# ROD AMENDMENT

PURITY OIL SALES SUPERFUND SITE  
FRESNO, CALIFORNIA

## MEMORANDUM

**Subject:** Impermeable Cap Components  
Purity Oil Sales Superfund Site  
Fresno, California

SHEET 2 OF 2

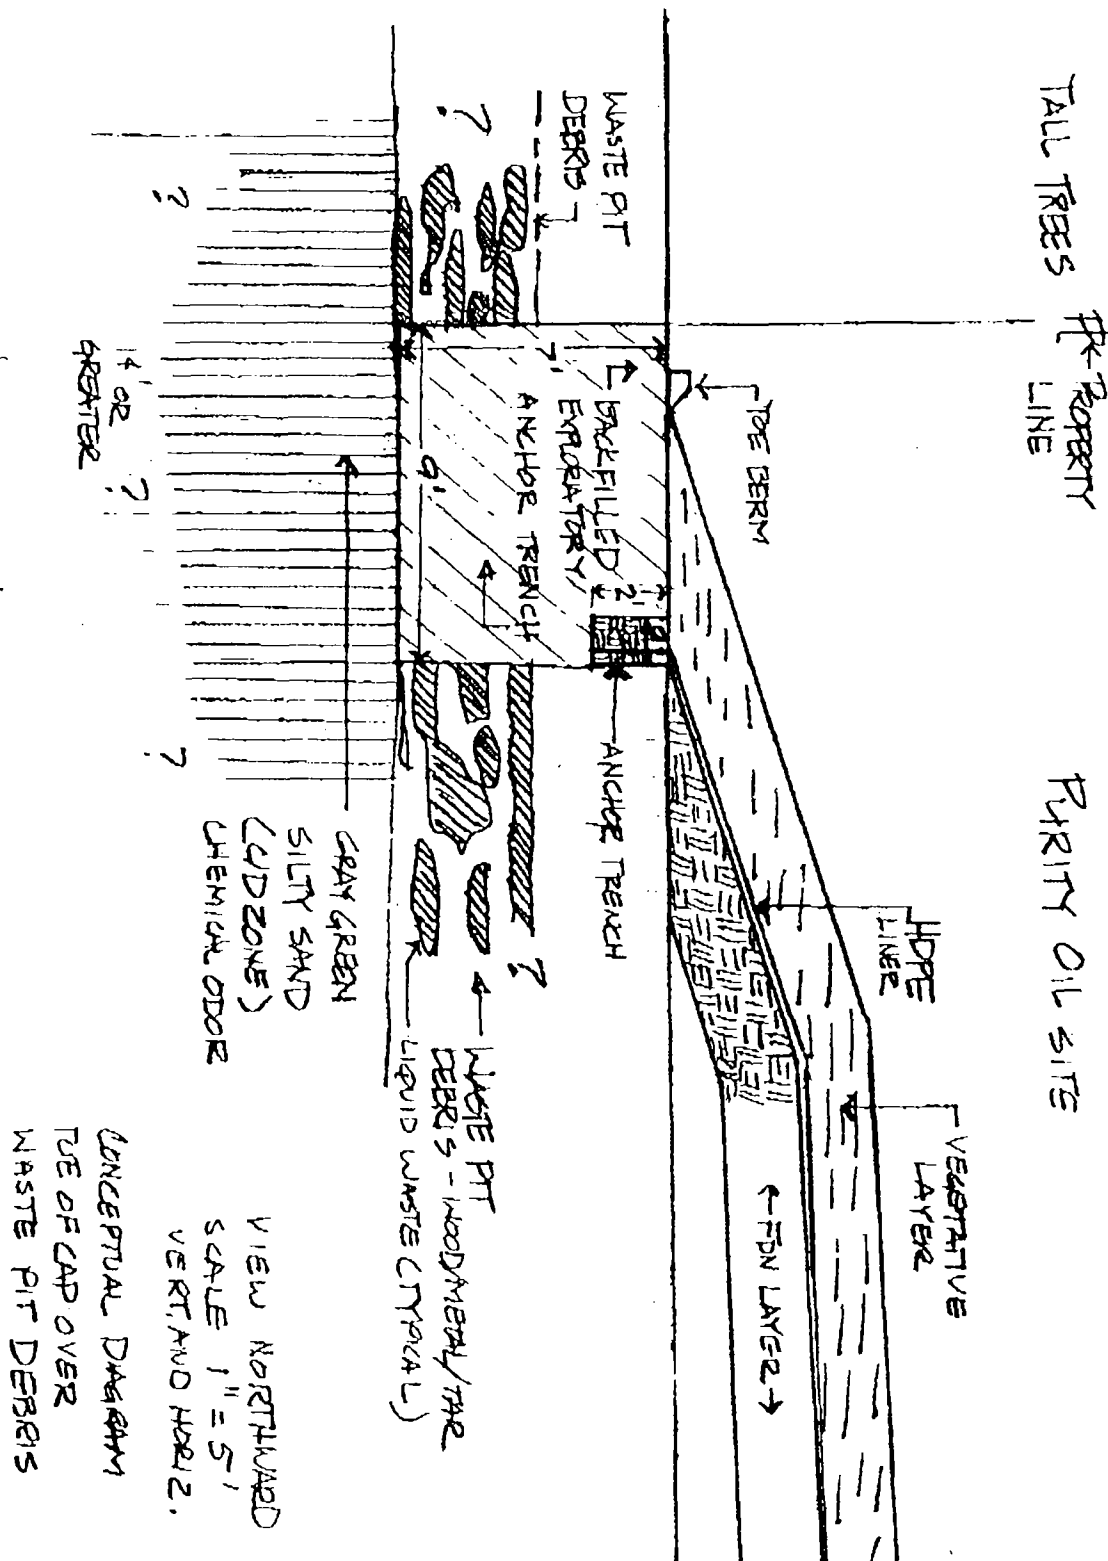
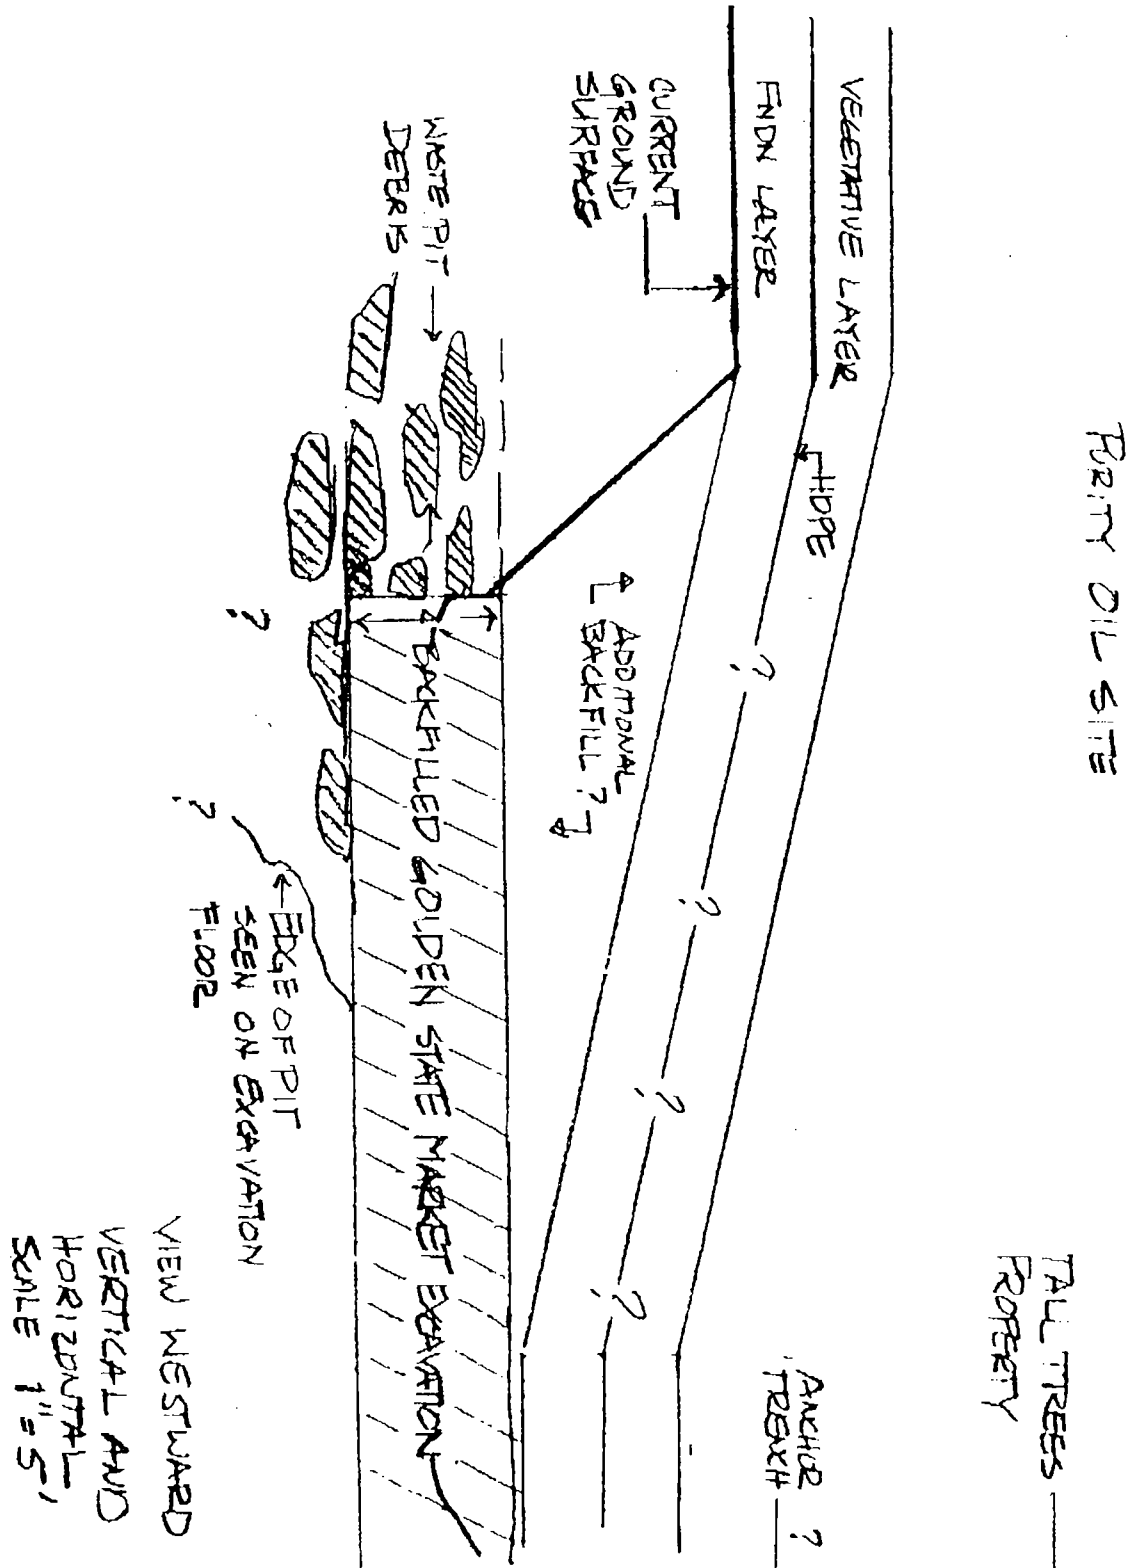
The situation encountered in the excavation of the anchor trench on September 20 and 21, 2001 is illustrated on Sheet 1 of 2. As shown by the diagram the trench excavation encountered waste pit debris and tarry acidic sludge from 3.5 to 7 feet on both sides of the trench with the floor of the trench encountering the Purity Oil C/D contaminant zone of gray greenish silts and sands. The exploratory anchor trench excavation encountered approximately 240 linear feet with the C/D contaminant zone and approximately 60 linear feet with in place waste pit material on both sidewalls. The current plan by IT and Chevron is to construct the anchor trench with the HDPE liner to a depth of 2 feet as originally designed after backfilling the exploratory anchor trench excavation.

When inspecting the area of the anchor trench excavation on September 28, 2001 some of the same concerns as discussed above became apparent in the area of the excavation behind the Golden State Market. The diagram on Sheet 2 of 2 depicts the situation that occurs in that area. In the excavation of the area behind the Golden State Market in place waste pit material was encountered along the south sidewall and on the southern third of both the east and west sidewalls indicating that the southern third of the excavation was located over one of the Purity Oil waste pits. The specific concerns are created by the lack of clarity in the design documents and subsequent revisions as the location of the edge of the cap in this area. No details have been provided and the latest version of the subgrade drawing 7A implies that the edge of the cap and the anchor trench are located on the southern edge of the excavation area behind the Golden State Market which would create the same issues as noted above. If the actual design intent is to locate the anchor trench on the northern boundary of the Golden State Market excavation area then these issues will not exist.

All of these issues dictate the need for strong monitoring approach as part of the O&M of the site of look for any seepage of gas or liquids, change in the cap configuration such as slip, settling or upheaval. All of these would require metrics to evaluate the performance of the cap along with a agreed approach or process on how to address potential problems in the future.

Purity Oil Sales Superfund Site - G00DA-193008 Photo # 1404  
Tar seep at toe of North slope (looking east)

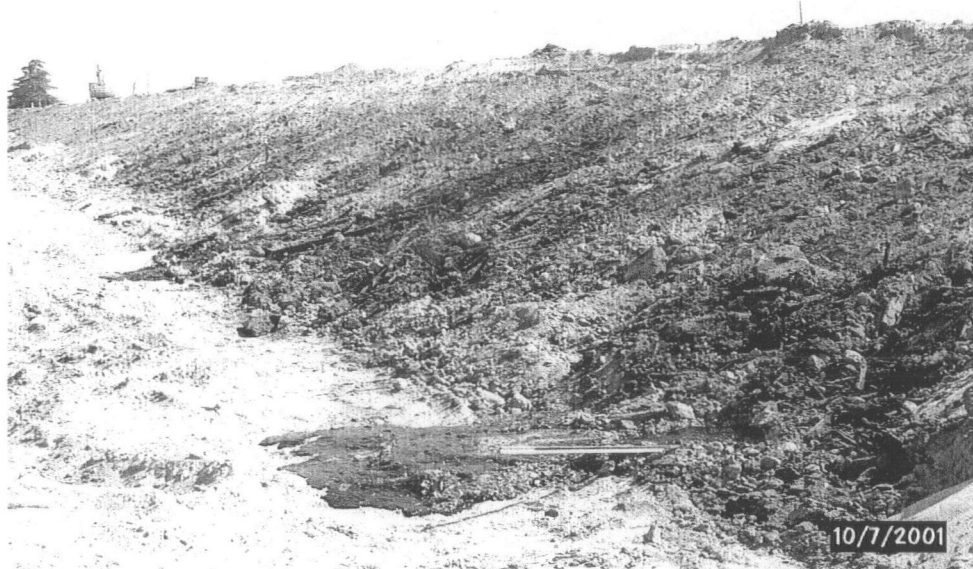
As a result of excavation on the North Slope, to achieve the elevations and grades depicted on Drawing 7A included as part of Request For Information (RFI) 26, several tar seeps have appeared at the toe of the North Slope (see attached photographs and site map). As part of Tetra Tech EM Inc. (Tetra Tech) letter to SECOR International Incorporated (SECOR) on September 26, 2001, "Review of Request For Information Numbers 24, 25 (Revision No. 2) and 26", Tetra Tech stated that, "If anomalous low strength materials are discovered during construction, the stability analysis should be reevaluated". Do these tar seeps satisfy the previous statement?

193008, Photograph # 1529; North Tar Seep located in Grid S.

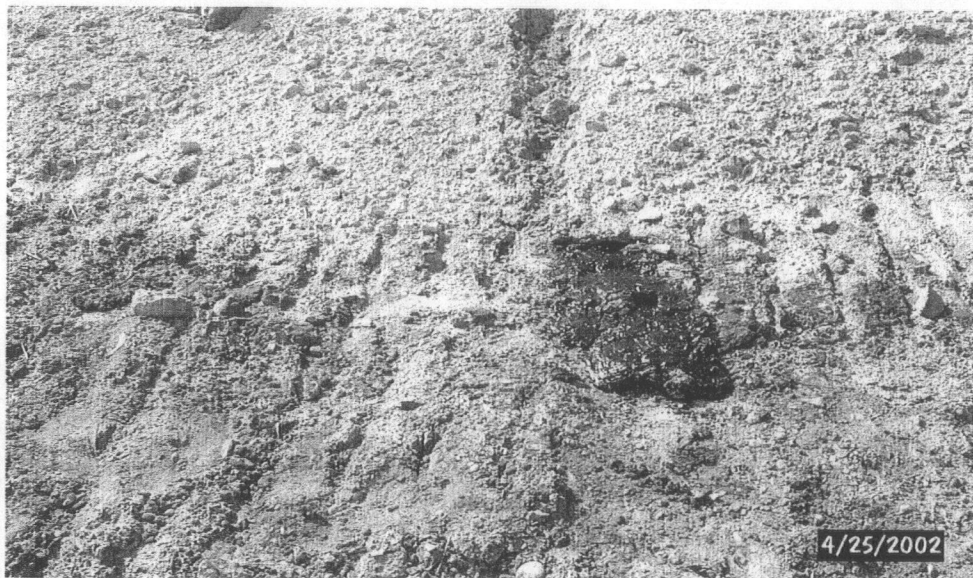
(NOTE: Internal pressure within the subgrade layer appears to have forced the tar to rupture the north slope)
